OFFICIAL COORDINATION REQUEST FOR NON-ROUTINE OPERATIONS AND MAINTENANCE

COORDINATION TITLE - 17 MCN 04 Oregon Ladder Lamprey Plating Removal

COORDINATION DATE – 06 February 2017

PROJECT- McNary

Figure 1. Arial Photo of Diffuser in OR Ladder

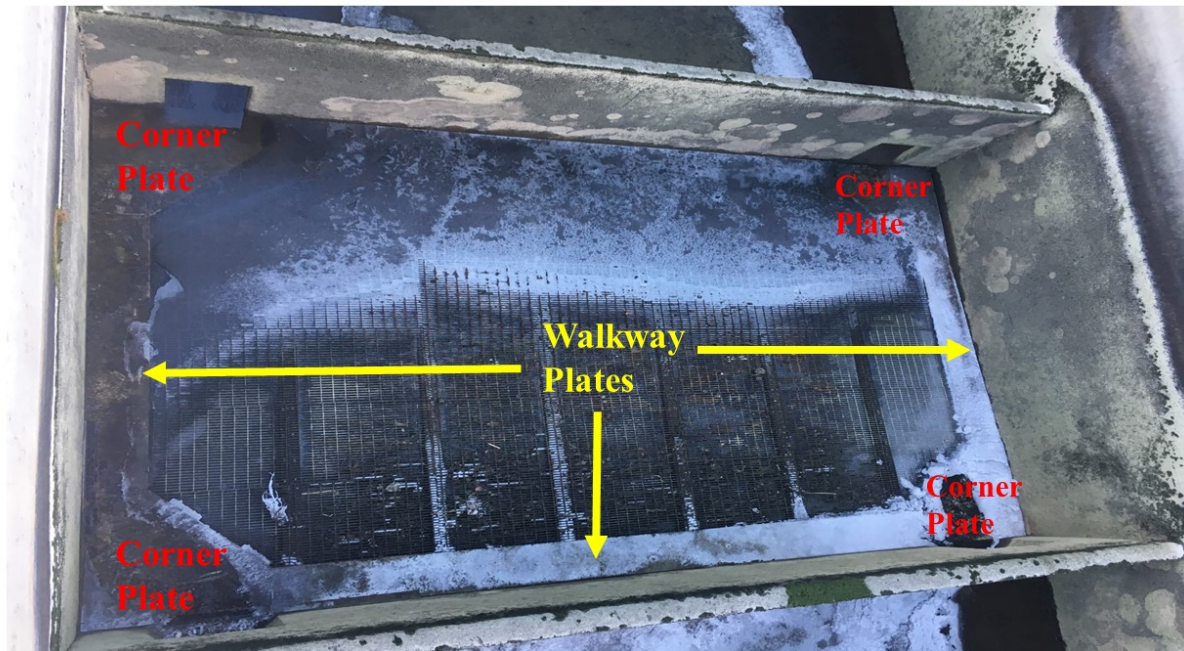
Description of the problem: The McNary Project is seeking approval to remove plating over diffusers 12 and 14 grating in the Oregon shore ladder that was originally installed to serve as passage aides for adult Pacific lamprey (Figure 1). Lamprey plates decrease flow area at diffusers and increase pressure on grates and increase the likelihood of grating failure.

The lamprey passage plating was installed in the Oregon shore ladder during the 2010 winter outage. They were intended to provide attachment locations for adult lamprey moving upstream through the ladders. However, there has been no evidence the plating have been used by lamprey (Steve Juhnke, NWW Lamprey Program Lead). Because of this, 2017 Washington shore ladder lamprey improvements did not include adding the plating over diffusers. When recently asked, Mr. Junke agreed that there was no reason the plating could not be removed from the Oregon shore fishway.

Yearend reports, show Oregon shore diffuser 11 supports failed in 2005 and 2010. Though the diffuser was not covered with plating, this reflects the amount of force along the west ladder wall. After installations in 2010, diffuser 14 walkways were repaired in 2011, diffuser 11 supports were repaired in 2013 and diffuser 13 supports along with

plating was repaired in 2014. For 2017, one corner plate at diffuser 14 needs to be reattached.

Approved by FPOM 2/9/2017. From meeting minutes: "MCN Lamprey Sidewalk Removal – FPOM concurred with this action".

Plates were removed.
